Subject: **Bid #: 7946-W3, Green Hill Park Community Garden / DPWP**

### **ADDENDUM NO. 2**

**Project:** Bid No. 7946-W3 **Greenhill Park Community Garden**  
**City of Worcester Department of Public Works and Parks**  
**Parks, Recreation and Cemetery Division**

**General Bid Clarification**

L143

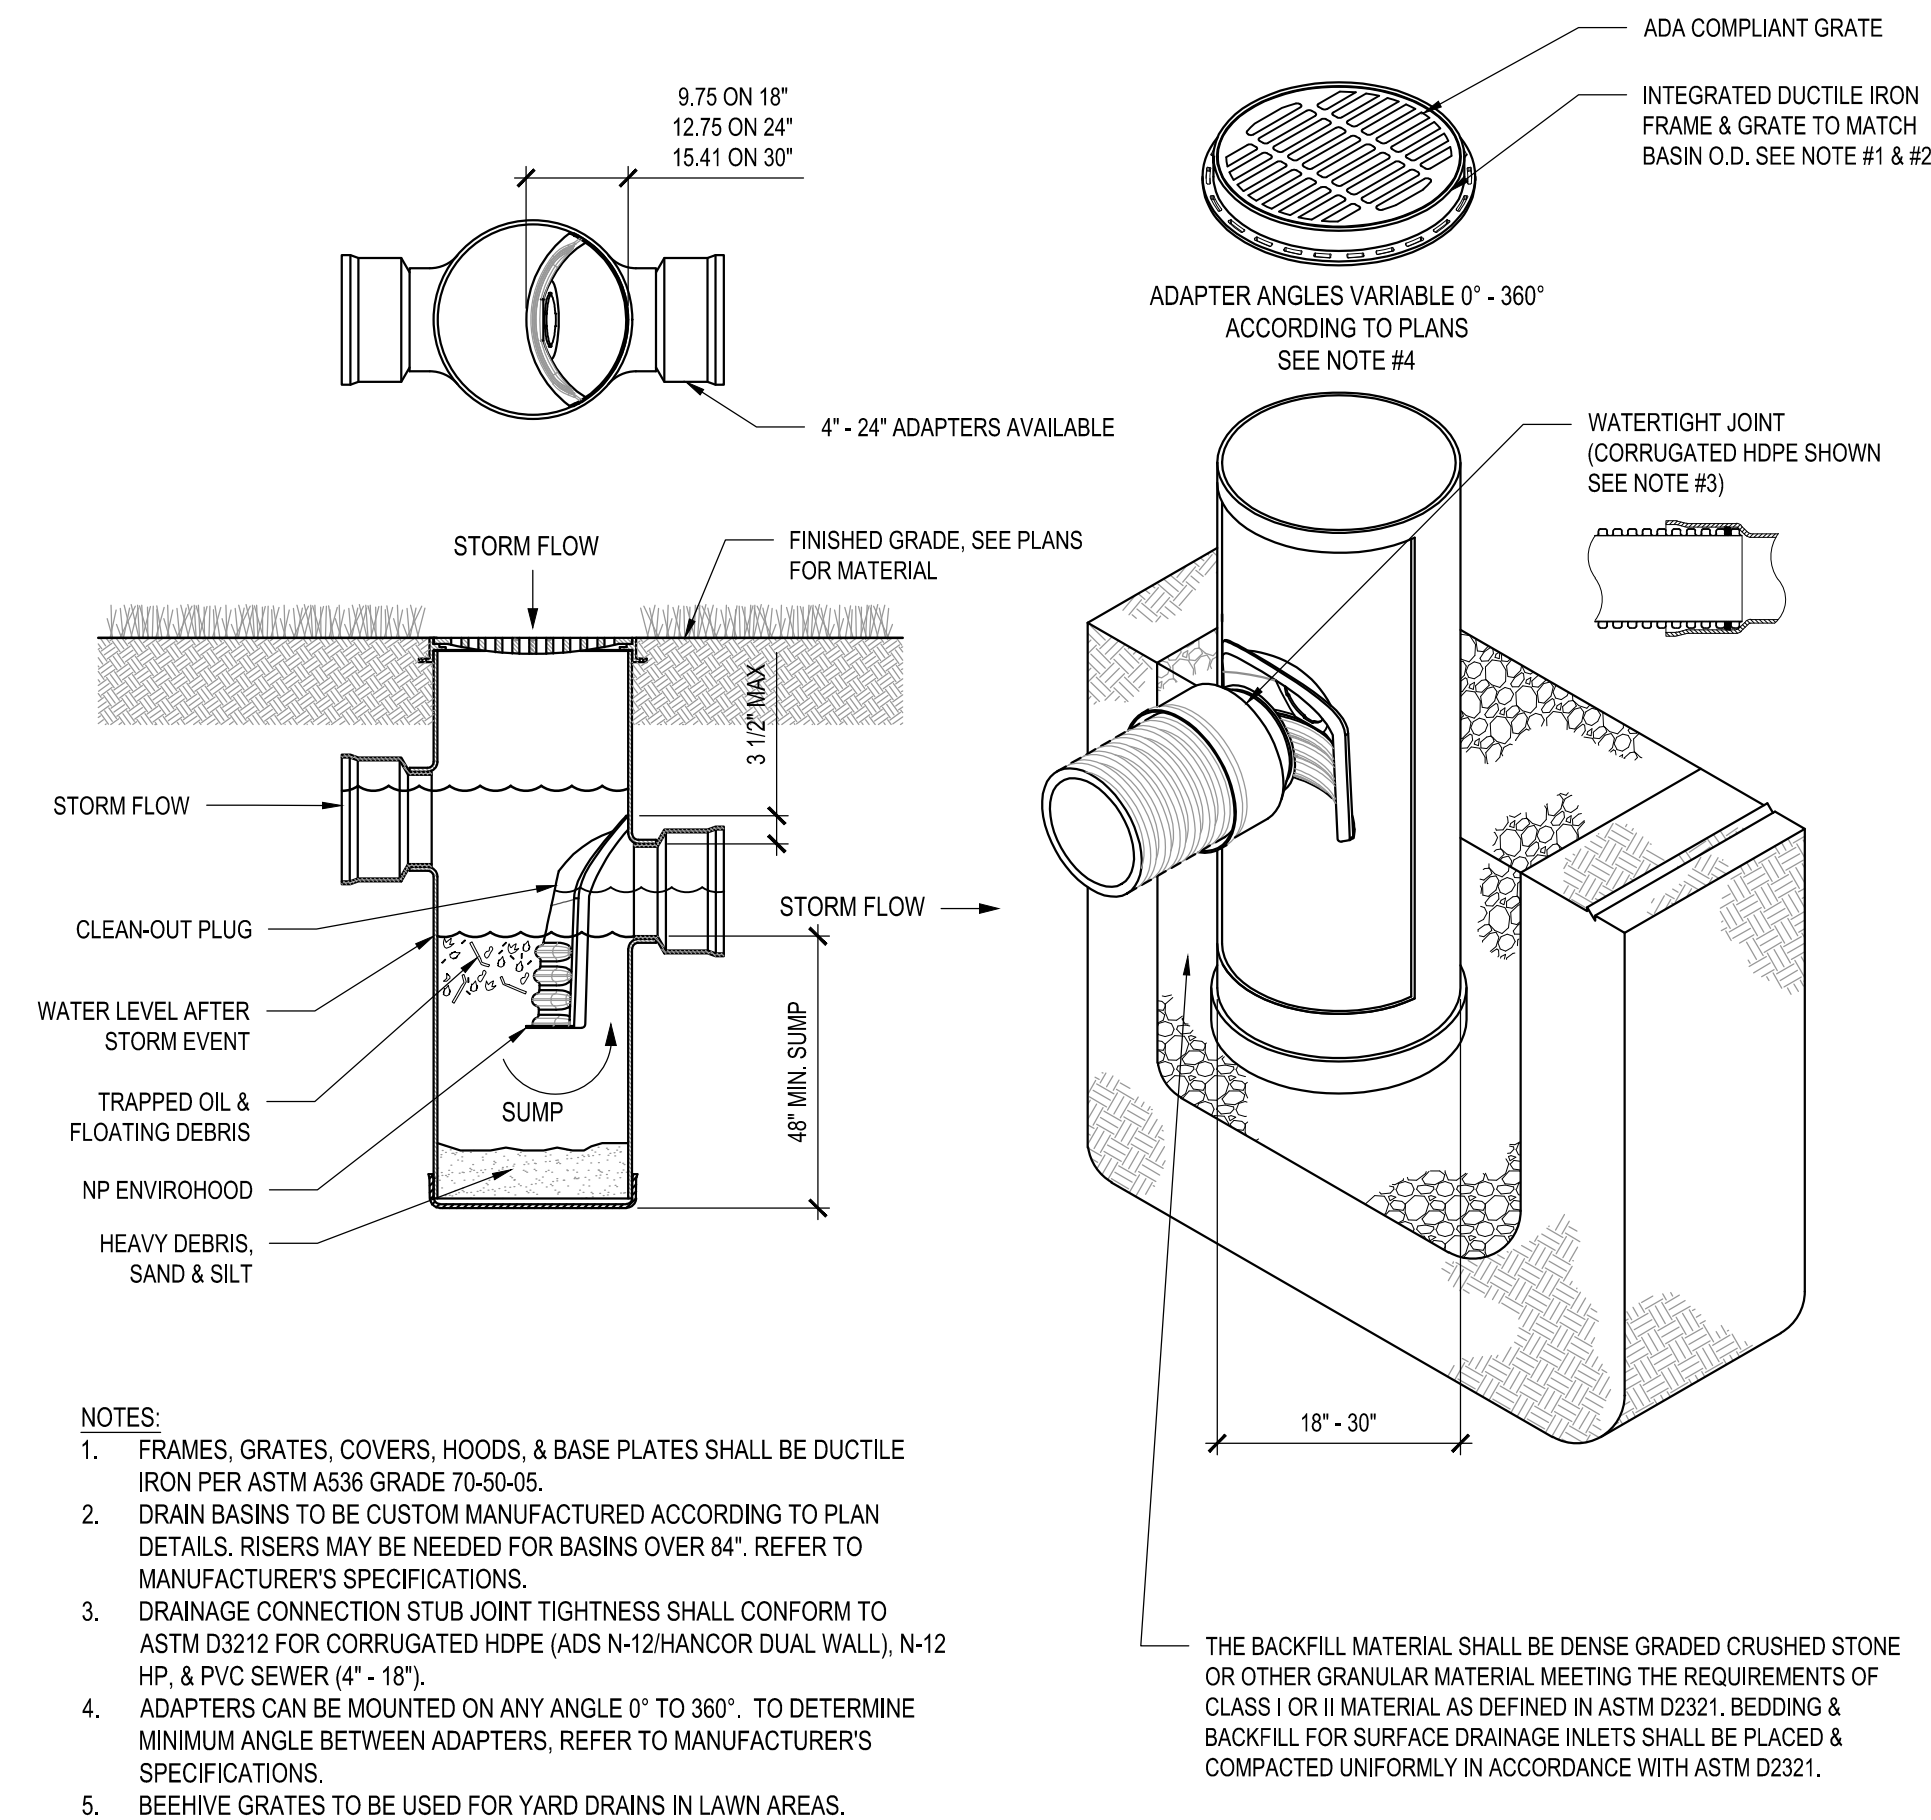
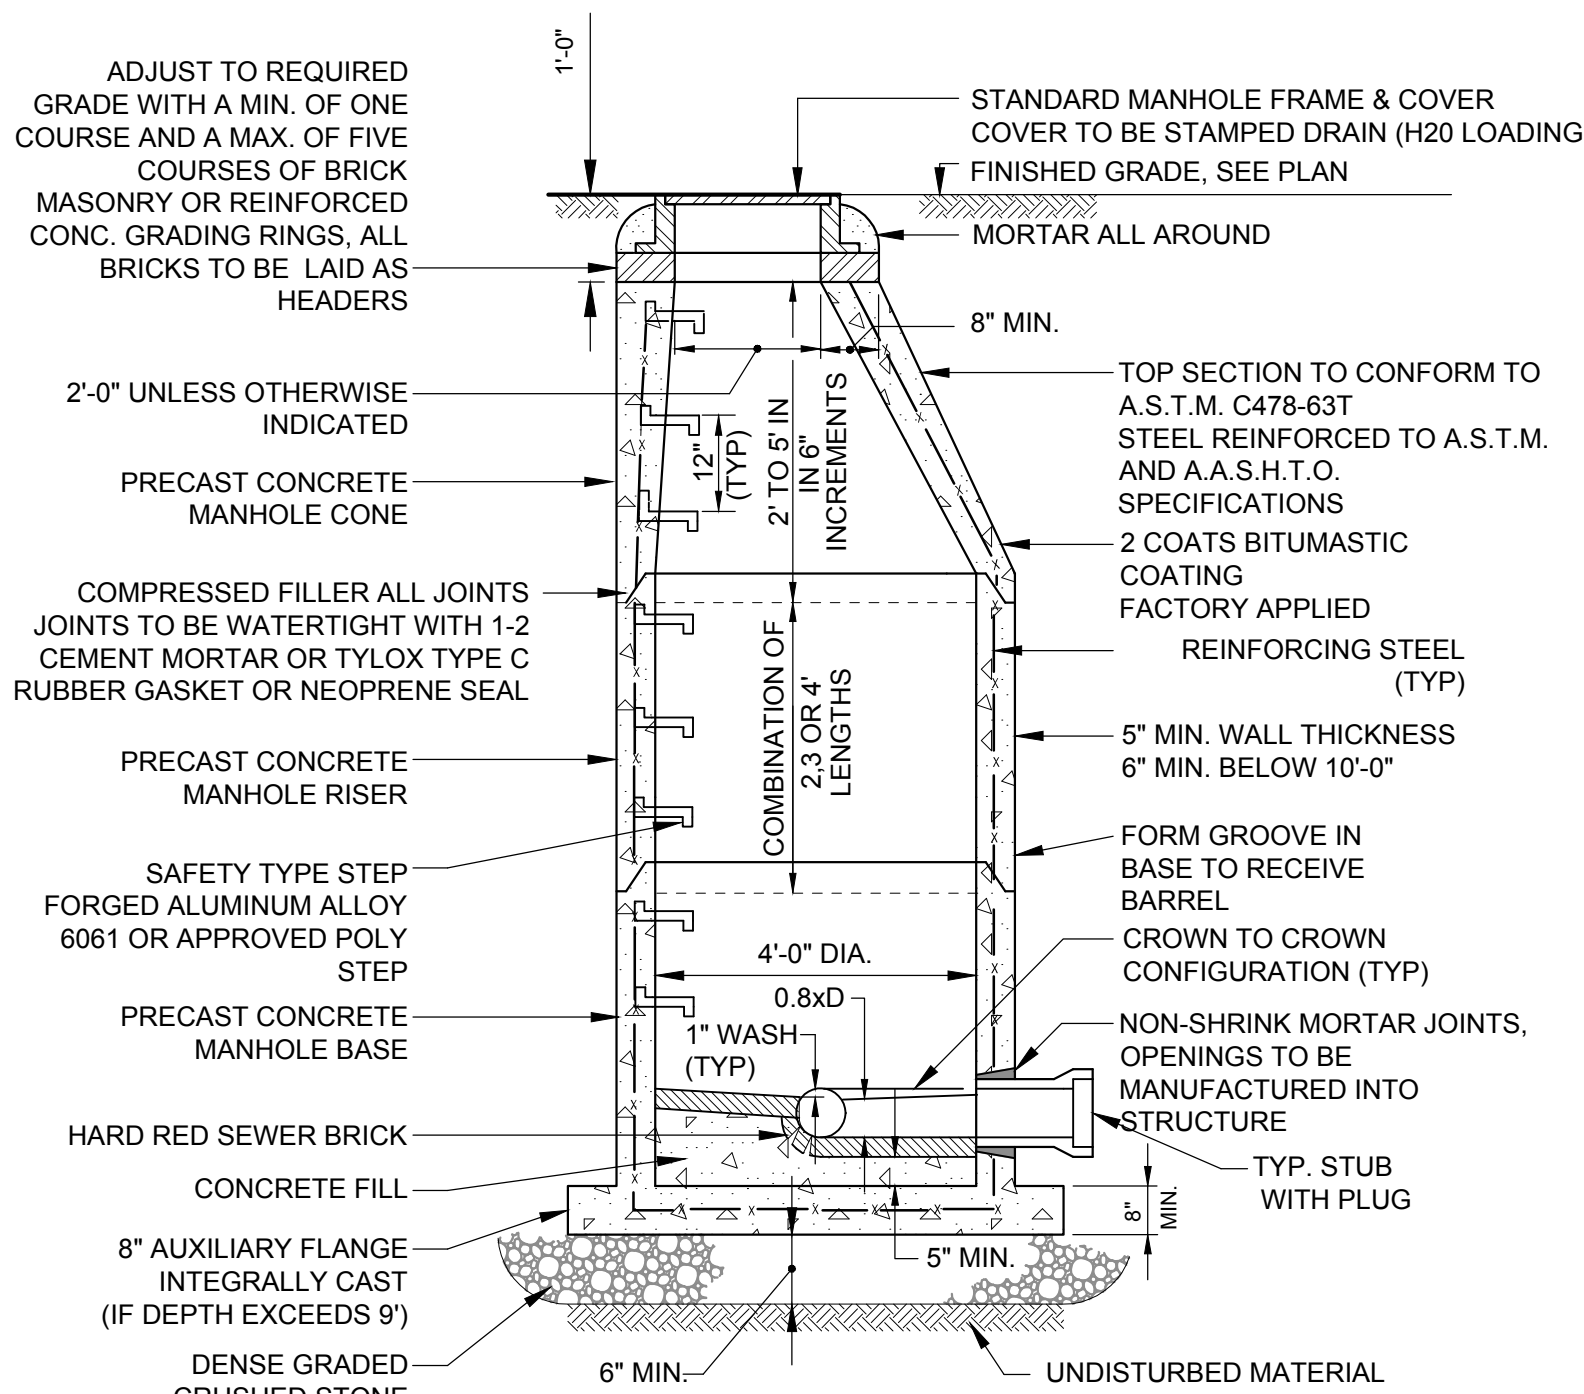
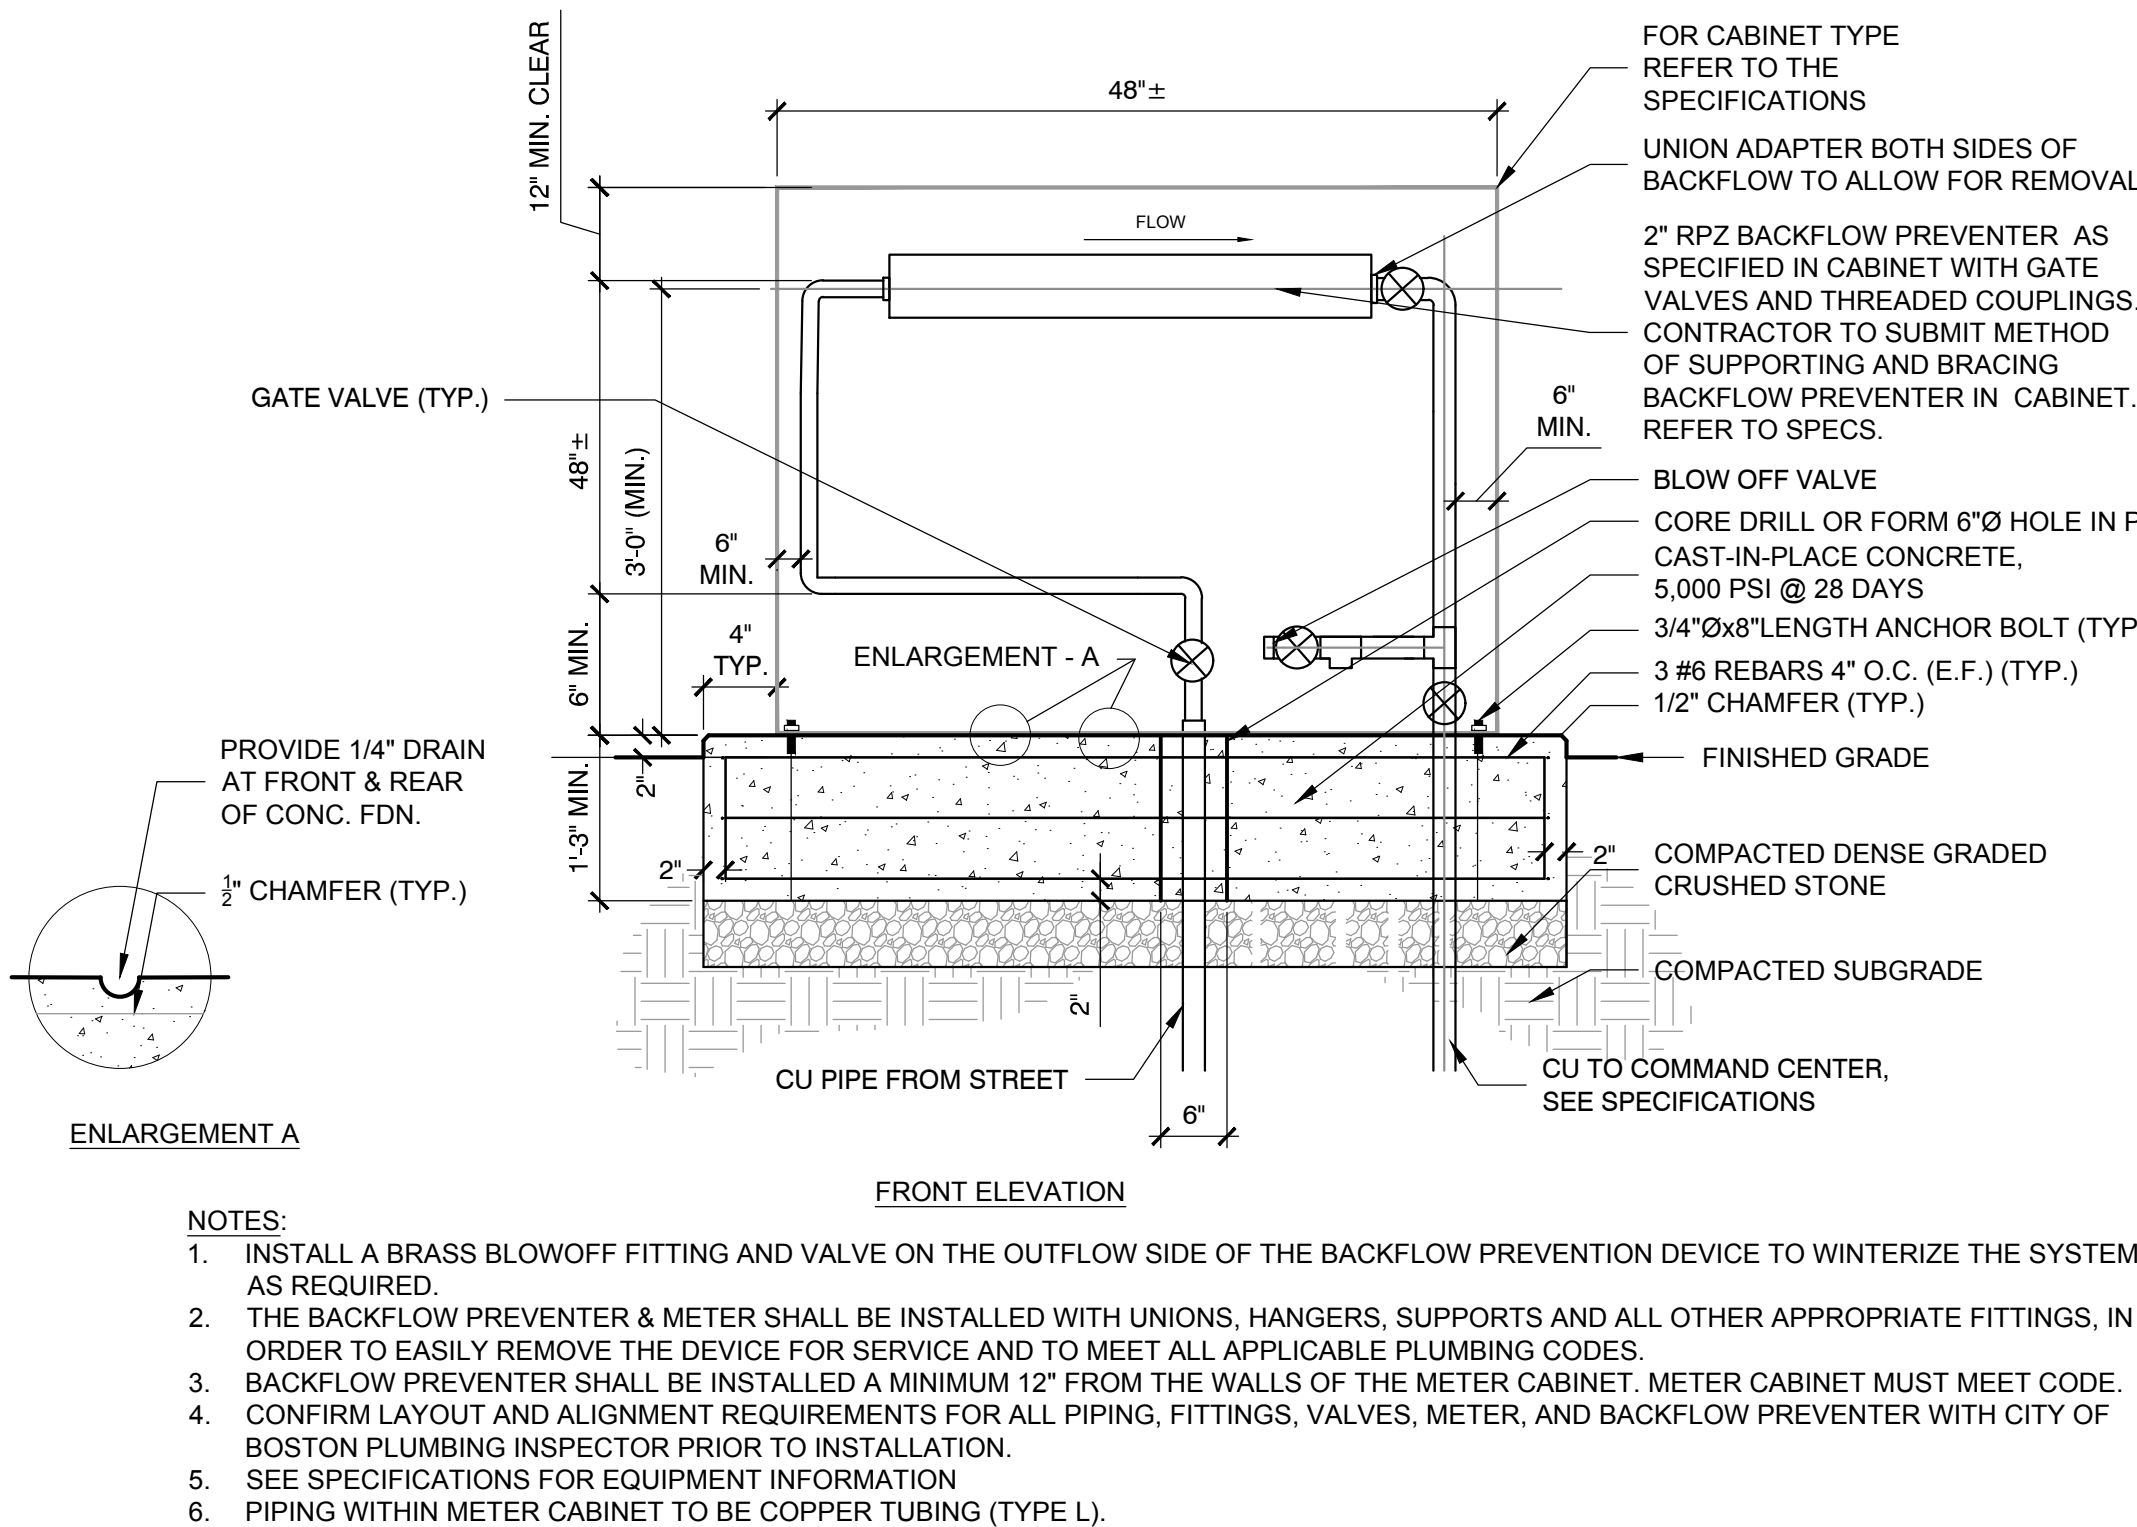
Question 16: The Utility Plan on Sheet L143 calls for a 4" perforated HDPE pipe adjacent to an existing stone wall that is to be repaired. According to the legend on the Grading and Drainage Enlargement Plan B on Sheet L142, this pipe is to be 6" solid HDPE pipe. The grading and drainage enlargement also shows a drain manhole and calls for a 6' diameter leaching basin in this area, however neither are shown on the Utility Plan. Please confirm what is to be installed at this location.

**Answer 16:** Confirmed. Pipe adjacent to existing wall shall be 4" perforated HDPE pipe. Leaching Basin shall be 18" DIA. Please refer to revise drawings.

**1 CAST-IN-PLACE CONCRETE PAVEMENT AND EXPANSION JOINT**  
NOT TO SCALE

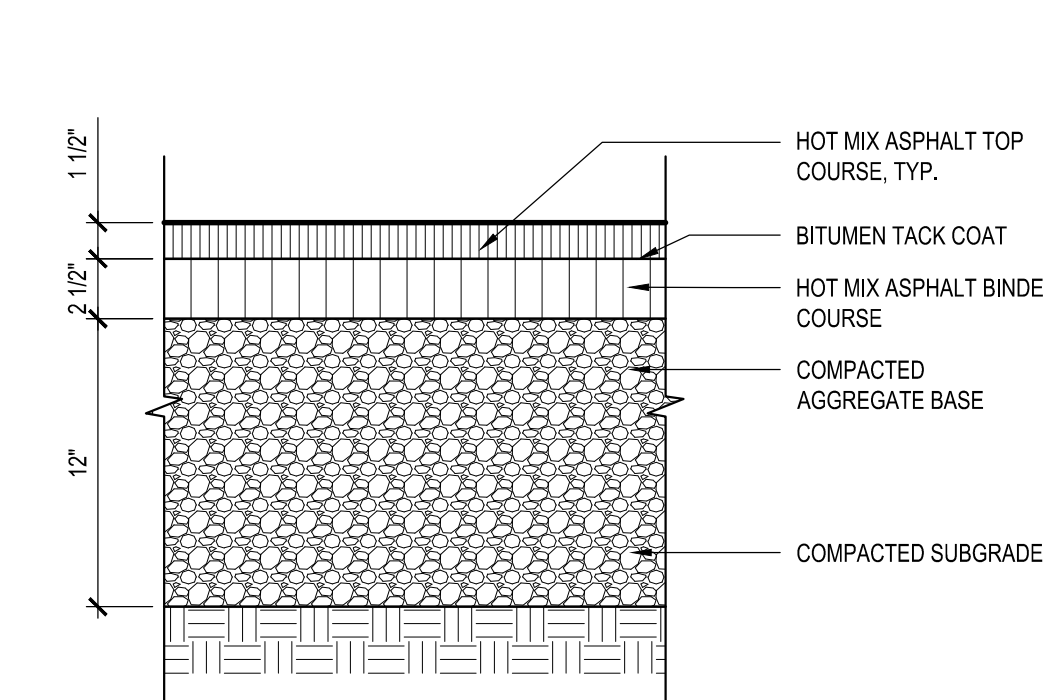
Question 14: Please clarify the depth of concrete paving. Detail #1 on Sheet L502 shows a 4" slab with no reinforcement. Is this the case for all concrete paving site wide? Detail #12 on Sheet L502 calls out the concrete paving as reinforced. Both Details #5 and #10 call for a 6" slab. If the concrete paving is to be 6" depth and reinforced, please provide reinforcing details.

**Answer 14:** Cast-in-place pavement shall be without reinforcement as shown in revised detail #1 Sheet L502. Please refer to revise drawings. See attachment 'L502 Site Construction Details', detail #1, #5, #10 and #12.
